PPPL ENGINEERING CHANGE NOTICE (ECN) ECN # 5185R1

ECN TITLE: Flange Hole Counterbore Clearance Envelope and Type-B Post Mod

CC/WP/Job: 9450-1*-1411** **AREA OR PROJECT: NCSX**

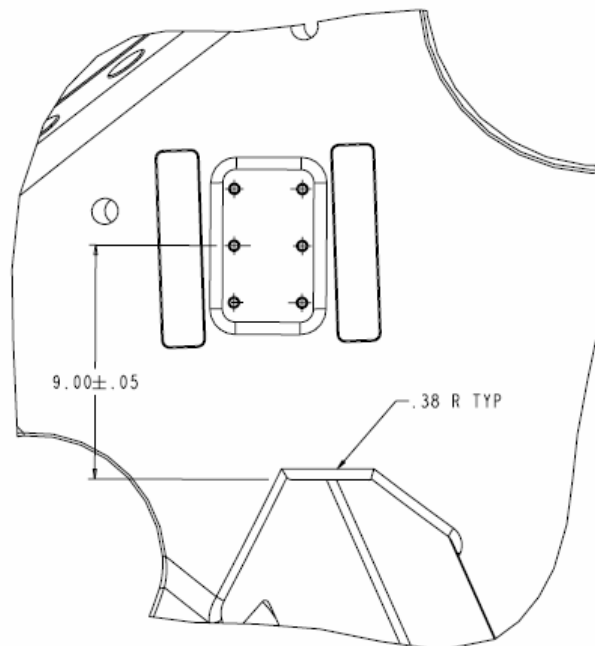
SE141-114, -115, -116, Sht-4, 5 -The clearance requirements for all flange back spot faces and for all the remaining winding forms (MCWFs C-6, B-3 through B-6, and A-4 through A6) shall be a 3" diameter cylinder 3" high from the spot face surface. The blend-in radius at the upper extent of this machined area shall be 1/4".

The CAD model of the counterbore envelope, 3-in dia x 3-in length with a spherical radius, is not large enough to provide adequate fastener clearance in heavy stocked areas of the casting.
